Access Compliance Report

Public Rights-of-Way

(Curb Ramps)

Intersection ID: 44452	Main Street: BAYVIEW_PY	Cross Street: BUCKHORN_ST	Location: SW
ADA ID: A131570B4B44	Ramp Type: PerpDiag	Initial Pass/Fail: Fail	Overall Compliance: No
			Severity Score: 36.25

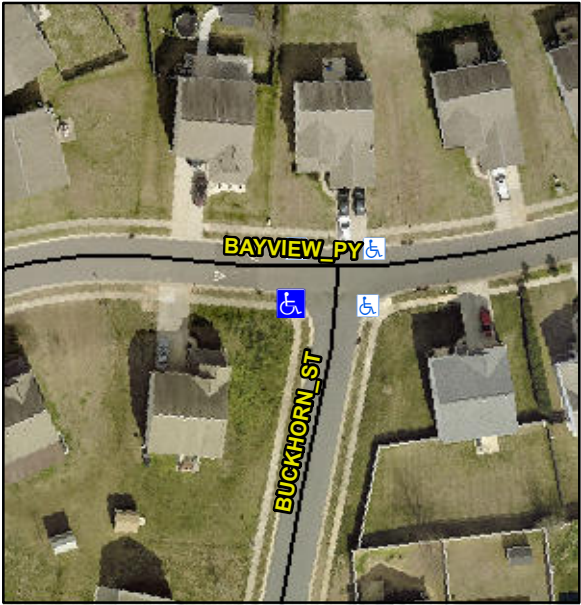
Codes/Mitigation Info/Possible Solution		Field Measurements/Component Compliance					
	Possible Solutions:						
	Remove & Replace Curb Ramp With Two New Directional Ramps or Equivalent.	N/A	Ramp Length (in)	49.5	Yes	Ramp Slope (%)	7.7
		No	Ramp Width (in)	30.0	No	Ramp XSlope (%)	2.7
		N/A	Flare Type LT	N/A	N/A	Flare Type RT	N/A
		N/A	Flare Slope LT (%)	N/A	N/A	Flare Slope RT (%)	N/A
		N/A	Flare Traversable LT?	N/A	N/A	Flare Traversable RT?	N/A
		N/A	Landing Length (in)	N/A	N/A	DWS Provided?	N/A
		N/A	Landing Width (in)	N/A	N/A	DWS Contrast?	N/A
		N/A	Landing Slope (%)	N/A	N/A	DWS Length (in)	N/A
		N/A	Landing X Slope (%)	N/A	N/A	DWS Full Width?	N/A
<p>Surveyor Notes:</p> <p>N/A</p> <p>PROW/ADA:</p> <p>R304.5.1, R304.5.3</p>		N/A	Landing Curb? (Y/N)	N/A	N/A	DWS Offset (in)	N/A
		N/A	Shared Landing?	N/A			
		N/A	Gutter Ponding?	N/A	N/A	Gutter Slope (%)	N/A
		N/A	Gutter Lip Ht (in)	N/A	N/A	Gutter X Slope (%)	N/A

N/A	Painted X Walk1?	No	N/A	Painted X Walk2?	No
			X Walk 1 Direction	To E		X Walk 2 Direction	To N
		N/A	X Walk 1 Width (in)	N/A	N/A	X Walk 2 Width (in)	N/A
			X Walk 1 Slope (%)	0.5		X Walk 2 Slope (%)	3.2
			X Walk 1 X Slope (%)	0.7		X Walk 2 X Slope (%)	0.0
		N/A	Ramp inside XWalk1?	N/A	N/A	Ramp inside XWalk2?	N/A
<p>Street 1 Name</p> <p>Stop Condition-Street 2</p> <p>Street 2 Name</p> <p>Stop Condition-Street 1</p>	BUCKHORN ST <p>StopSign</p> <p>BAYVIEW PY</p> <p>None</p>						
			Road Slope (%)	1.5	N/A	Clear Space?	N/A
			Road X Slope (%)	0.0	N/A	Clear Space to XWalk (in)	N/A
		N/A	Any Obstructions?	N/A	N/A	Storm Grate/Utility Hazard?	N/A
			Obstruction Type			Storm Grate/Utility Type	
					N/A		N/A
					Yes	Surface Condition? (G/P)	Good
Total Cost:		\$	3200.00
